MARINE MAMMAL COMMISSION

24 June 2013

The Marine Mammal Commission, in consultation with its Committee of Scientific Advisors on Marine Mammals, has reviewed the application submitted by the Scripps Institution of Oceanography seeking authorization under section 101(a)(5)(D) of the Marine Mammal Protection Act to take small numbers of marine mammals by harassment. The taking would be incidental to a marine geophysical survey to be conducted in the western tropical Pacific Ocean from September through October 2013. The Commission also has reviewed the National Marine Fisheries Service's 5 June 2013 notice announcing receipt of the application and proposing to issue the authorization, subject to certain conditions (78 Fed. Reg. 33811).

The Marine Mammal Commission, in consultation with its Committee of Scientific Advisors on Marine Mammals, has reviewed the application submitted by the Southwest Fisheries Science Center (Center) seeking authorization under section 101(a)(5)(A) of the Marine Mammal Protection Act to take small numbers of marine mammals by harassment. The taking would be incidental to fisheries research activities during a five-year period. The Commission also has r

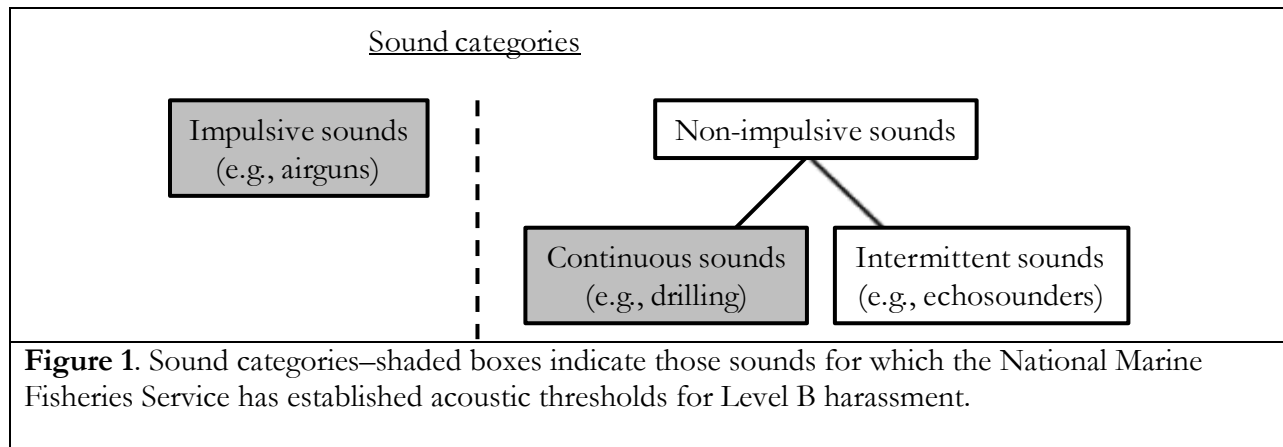
The Service has categorized sound sources as either impulsive or continuous to establish acoustic criteria and thresholds for Level B harassment (70 Fed. Reg. 1871; see Figure 1). Impulsive sounds are those with a rapid rise time, high peak pressure, and rapid decay. They are brief (<1 second) and may be repetitive (e.g., an airgun) or singular (e.g., an explosion). Non-impulsive sounds do not have those characteristics and they can be divided into those that are either temporally continuous or intermittent. Continuous sounds are those for which the sound pressure level is elevated consistently above the ambient level during the operation of the sound source—they are not interrupted by a silent period. Examples include sounds from drilling and vessel engines or dynamic positioning systems.

Relying on the results of Malme et al. (1983, 1984), the Service established a 160-dB re 1 μ Pa threshold to estimate the area (or zone) in which animals could be harassed by impulsive sounds and a 120-dB re 1 μ Pa threshold to estimate the area (or zone) in which animals could be harassed by continuous sounds. However, the Service has yet to establish or apply a consistent threshold for non-impulsive, intermittent sounds, such as those produced by echosounders and fish-finding sonars proposed for use by the Center. Those sources generally emit a steady ping, ping, ping that do not exhibit the rapid rise, high peak pressure, and rapid decay used to define impulsive sounds,

but they also are not continuous. Based on their characteristics, echosounders and sonars fall into a category of sounds for which the Service has yet to establish a threshold.

Although the Service has proposed to use the 160-dB re 1 μ Pa threshold for the sound sources that the Center would use, it has not applied the 160-dB re 1 μ Pa threshold consistently to all non-impulsive, intermittent sources. In a 2011 notice (76 Fed. Reg. 43639) the Service determined that for non-impulsive sound sources, whether continuous or intermittent, Level B harassment is presumed to begin at received levels of 120 dB re 1 μ Pa. Recently, the Service reiterated that position when it indicated that Level B harassment is considered to have occurred when marine mammals are exposed to sounds at or above 120 dB re 1 μ Pa for non-pulsed (i.e., non-impulsive) sounds (78 Fed. Reg. 22096). Consistent with that more precautionary determination, the Commission has recommended in numerous letters that the Service require applicants to recalculate Level B harassment zones for non-impulsive, intermittent sounds based on the 120-dB re 1 μ Pa threshold for non-impulsive sounds, rather than the 160-dB re 1 μ Pa threshold used by the Service for impulsive sounds. The Service has disagreed with that recommendation.

Therefore, until such time that the Service includes non-impulsive, intermittent sounds in its revised acoustic criteria and thresholds, the Marine Mammal Commission recommends that the National Marine Fisheries Service require the Center to re-estimate the numbers of marine mammals taken based on the 120-dB re 1 μ Pa threshold rather than the 160-dB re 1 μ Pa threshold. The Marine Mammal Commission further recommends that the Service consult with experts in the field of sound propagation and marine mammal hearing to revise the acoustic criteria and thresholds as necessary to specify threshold levels that would be more appropriate for a wider range of sound sources, including echosounders and fish-finding sonar.
